DEVELOPMENT APPLICATION ASSESSMENT REPORT

Application Number:	DA2019/1280
Responsible Officer:	Lashta Haidari
Land to be developed (Address):	Lot 3B DP 164259, 62 Beaconsfield Street NEWPORT NSW 2106 Lot 4A DP 159498, 11 Queens Parade NEWPORT NSW 2106 Lot 3A DP 164259, 9 Queens Parade NEWPORT NSW 2106 Lot 2 DP 209106, 7 Queens Parade NEWPORT NSW 2106 Lot 5A DP 158658, 13 Queens Parade NEWPORT NSW 2106 Lot 4B DP 159498, 60 Beaconsfield Street NEWPORT NSW 2106
Proposed Development:	Demolition works and construction of a multi unit housing development with associated carparking and landscape works.
Zoning:	R3 Medium Density Residential
Development Permissible:	Yes
Existing Use Rights:	No
Consent Authority:	Northern Beaches Council
Delegation Level:	NBLPP
Land and Environment Court Action:	No
Owner:	Adcock Group Management Pty Ltd
Applicant:	Stable Innovations Pittwater Shores Pty Ltd
Application Lodged:	14/11/2019
Integrated Development:	No
Designated Development:	No

Figure 1 - Showing the relationship of the proposed development with the boundary of No. 58 Beaconsfield Street, (Source architectural plans as amended, prepared by Nettelontribe)

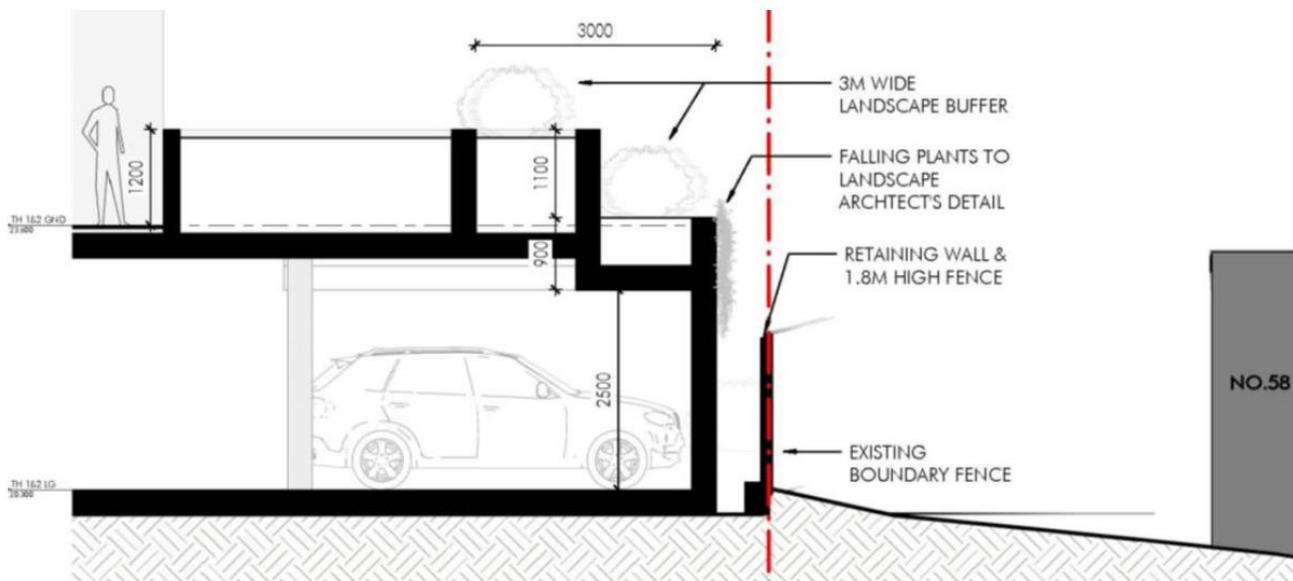
The proposal as originally submitted to Council, proposed that a garden terrace extend over the carparking at a level of RL24.6, i.e. 4.3m above the level of the rear yard of 58 Beaconsfield Street. The proposal (as amended) steps the raised landscaped area down as it nears the boundary with 58 Beaconsfield Street. Immediately adjacent to the boundary, the proposal is at ground level, then there is a planter box with cascading plants creating a green wall up to RL23.7, as shown in the following drawing:

The concern raised is noted and is addressed in the amended plans.

Figure 2 - Building Height Non-Compliance (Source: Statement of Environmental Effects, prepared by Symons Goodyer)

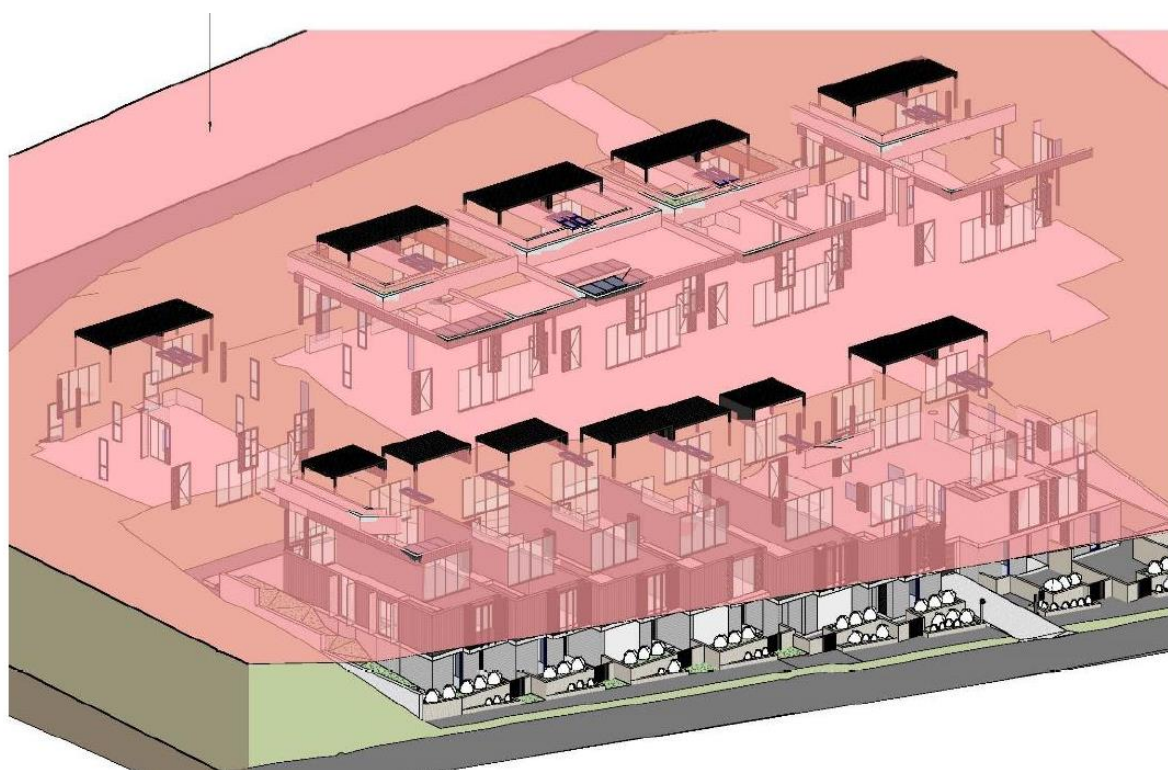
Development Standard:	Height of Buildings
Requirement:	8.5m
Proposed:	Dwellings - 8.5m Canopies above rooftop terraces - 9.6m
Percentage variation to requirement:	12.9%

The variation to the control is to enable the installation of roofing over the principal private open spaces (roof terraces) of the proposed dwellings which will provide two significant benefits.

When considering that the proposed roofing structures will not have negative impacts in terms of privacy, views or solar access for neighbouring and nearby properties, the benefits listed above provide sufficient environmental planning grounds to justify varying the development standard.

Figure 3: Western Elevation - Non-compliance with Side Boundary Envelope, shown in yellow (source: Statement of Environment Effects by Symonds Goodyer).

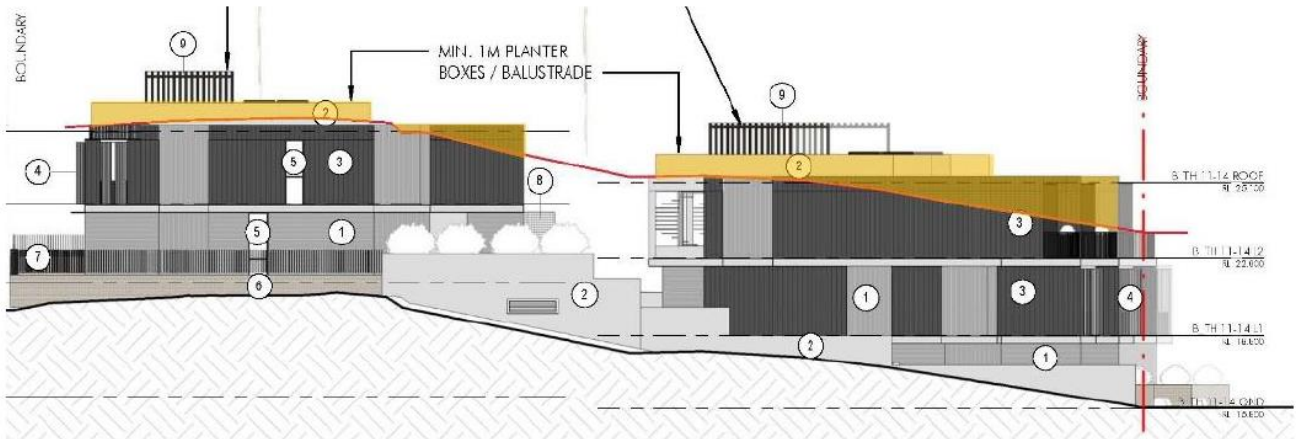
Western Elevation - The breach is measured to have an overall length of 23.0m across the two

buildings with an overall height of 1.8m (variation of 75%) as shown in the diagram below (non-compliance is highlighted in yellow).

Because the non-compliance's are predominantly located on the western boundary, which adjoins a B1 commercial zone, and due to the topography of the land, the development will not add to the bulk and scale of the building, such that it will unreasonably dominate its surrounds within the medium density zone.
